## REVISED RESPONSE TO REQUEST FOR ADDITIONAL INFORMATION

### APR1400 Design Certification

Docket No. 52-046

RAI No.: 199-8223  
 SRP Section: 03.08.01 - Concrete Containment  
 Application Section: 03.08.01  
 Date of RAI Issue: 09/08/2015

Figure 3.8-26 Code Jurisdiction Boundary of Common Basemat

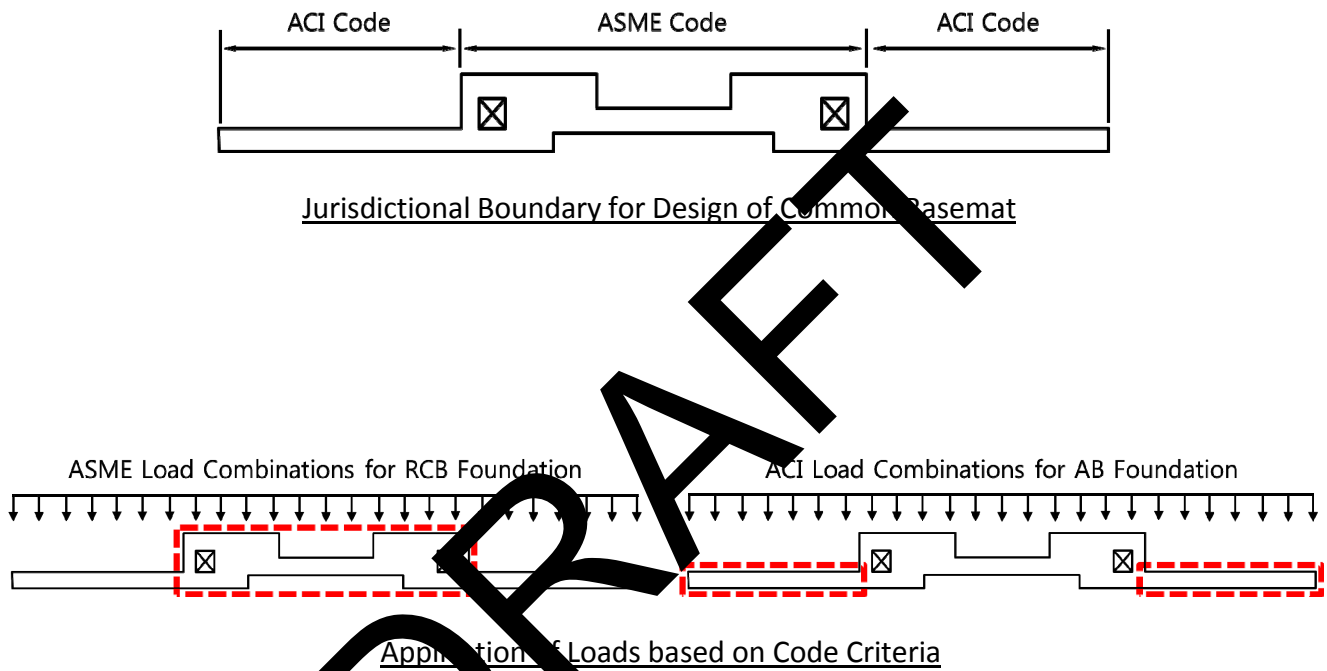
The containment structure, including the basemat directly beneath the containment is integral with the auxiliary building (AB) basemat. The staff noted that Section 3.8.1 of the DCD Tier 2 does not describe the jurisdictional boundary for design of the containment in accordance with ASME Section III, Division 2, Subsection CC. In accordance with Appendix A to 10 CFR Part 50, General Design Criteria 1, 2, 4, 16 and 50, and SRP 3.8.1, the applicant is requested to identify the jurisdictional boundary of the containment for design in accordance with ASME Section III, Division 2 Code, and describe what aspects of the design incorporates additional design requirements beyond the portion of the containment foundation directly beneath containment shell. In addition, the applicant is requested to update Section 3.8.1 of the DCD Tier 2 accordingly.

The design basis of the NI common basemat under the RCB and the AB conform to the requirement of ASME Section III, Division 2, Subsection CC and ACI 349, respectively. The boundary of jurisdiction between the ASME and the ACI codes is shown in Figure 3.8-26. The jurisdictional boundary is placed at the thickness transition interface due to the physical configuration and functional requirements of the basemat. The anchoring of the containment shell reinforcement is limited within the ASME code boundary as shown in Figures 3.8A-16 and 3.8A-17.

As the design criteria for the two portions of the basemat are different, the application of loads is also divided into two parts, as shown in Figure 3.8-26. The load combinations provided by the ASME and the ACI codes are used in the analysis and design of the RCB and AB foundations, respectively. At the interface between the ASME and ACI codes, a greater amount of reinforcement required by either code is used, and the reinforcement of the RCB foundation is developed into the AB foundation as shown in Figures 3.8A-16 and 3.8A-17. The provisions of both codes are used to select a conservative development length. The portion beyond the RCB foundation, i.e., the entire AB foundation area, is conservatively designed using the larger member forces from the analysis results of the ASME and ACI codes.
